Work Order ID 129105

Item Name: Baggage Compartment Protector - Floor And Wall

DART SERVICE INSTRUCTION

TO AMEND INSTALLATION INSTRUCTIONS IIN-D407-781-2 REV. A OR LATER APPROVED REVISION
AND INSTRUCTIONS FOR CONTINUED AIRWORTHINESS ICA-D407-781 REV. 3 OR LATER REVISION

**FIGURE 1 - D3879-1 BAGGAGE COMPARTMENT WALL
PROTECTOR - ALTERNATE INSTALLATION**

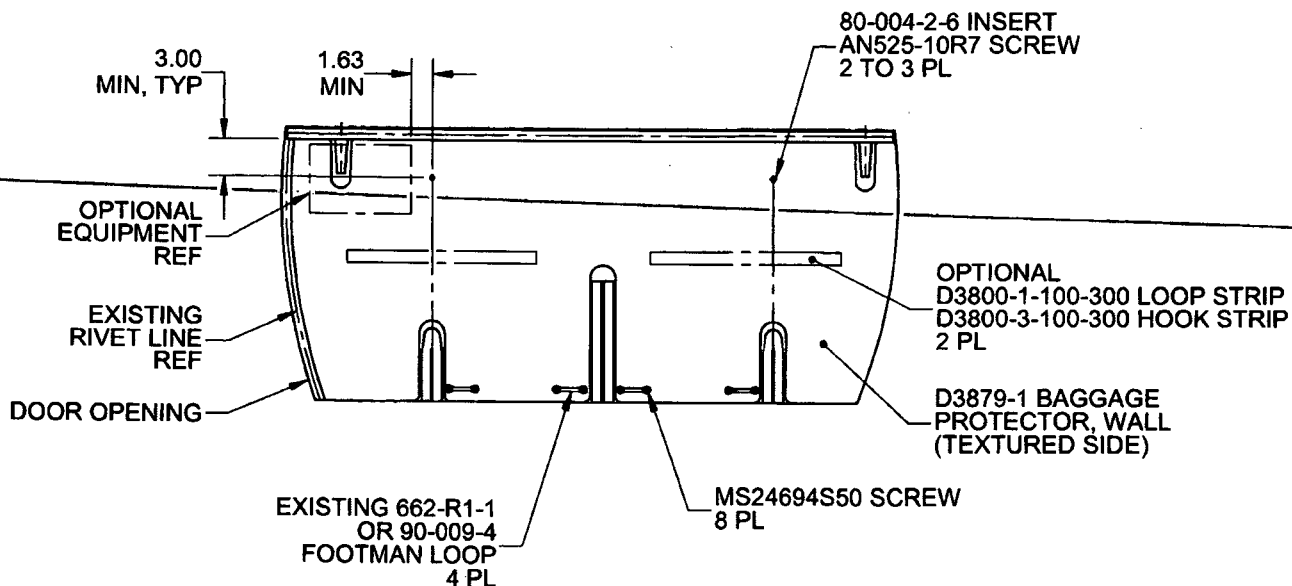
In some aircraft, the top portion of the D206-781-041 Baggage Compartment Wall Protector Kit cannot be installed as indicated in IIN-D407-781-2. The purpose of this DSI is to provide an alternate mounting method to fasten the top portion of the D206-781-041 Baggage Compartment Wall Protector Kit.

It is acceptable to replace qty(2) D3930-1 Clips with qty(2) 80-004-2-6 Inserts. Locate and mark location of the two attachment holes on the baggage compartment wall as shown in Figure 1 of this service instruction. Install 80-004-2-6 Inserts at the marked locations in accordance with Section 3-2-12 of BHT-206-SRM-1. It is acceptable to trim the wall protectors to accommodate optional equipment or transfer attachment holes to the wall protector and install the optional equipment on top of the wall protector with longer fasteners.

Amend the D206-781-041 Baggage Compartment Wall Protector Kit parts list as follows:

Qty -061	Qty -031	Qty -041	Part Number	Description
X			D206-781-061	BAGGAGE COMPARTMENT PROTECTOR KIT (FLOOR AND WALL)
1	X		D206-781-031	BAGGAGE COMPARTMENT FLOOR PROTECTOR KIT
1		X	D206-781-041	BAGGAGE COMPARTMENT WALL PROTECTOR KIT
		2	AN525-10R7	SCREW
		2	80-004-2-6	INSERT
